SERVICE BULLETIN

Subject: S-Series and K-Series Vertical Arm Set Screws
Applicable Products: S-Series and K-Series
Effectivity: All units manufactured on May 7, 2009; June 1, 2009; June 4, 2009

Figure 1: Main Shaft "Out" (Not Correct)

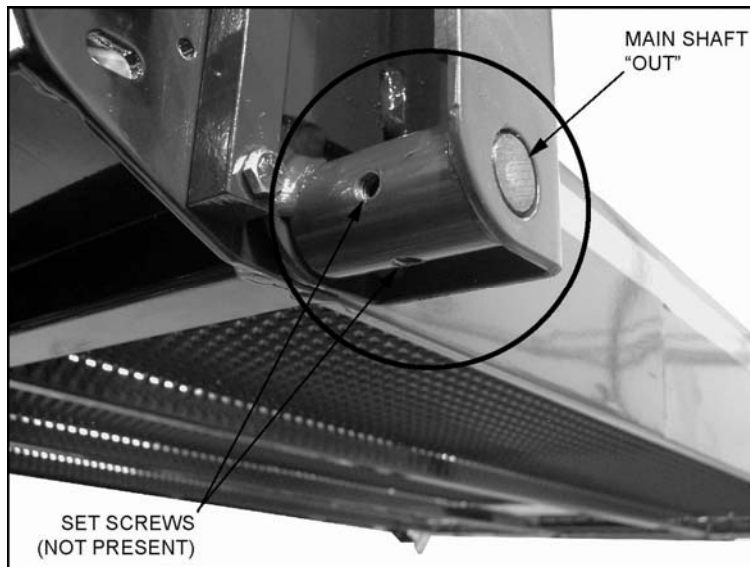
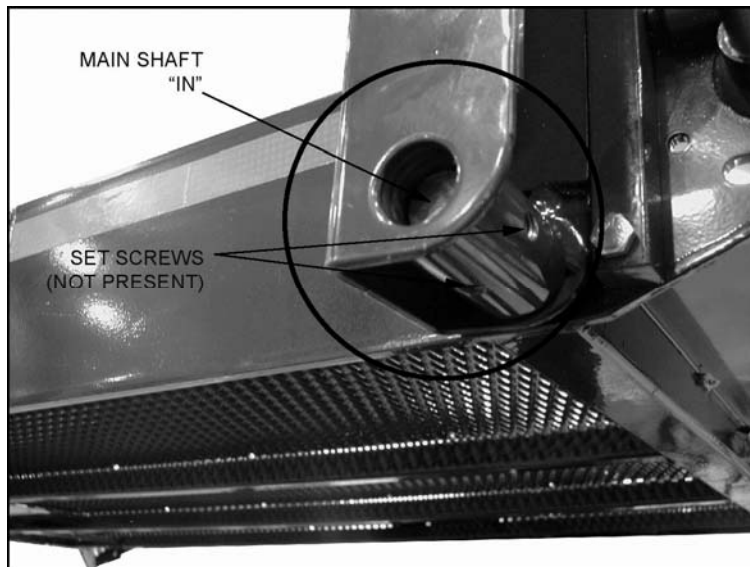
One S-Series and K-Series model manufactured on effective dates (May 7, 2009; June 1, 2009; June 4, 2009) were found to be missing set screws which can cause main shaft to separate from vertical arm, as shown in Figure 1 and Figure 2. Set screws with pre-applied medium strength thread lock must be installed to secure main shaft with vertical arm, as shown in Figure 3.

General inspection of units to ensure that set screws are present and to ensure main shaft is flush on both sides of platform. Contact Ricon for any required parts.

Vertical arm set screws with pre-applied tab of medium strength thread lock are required.
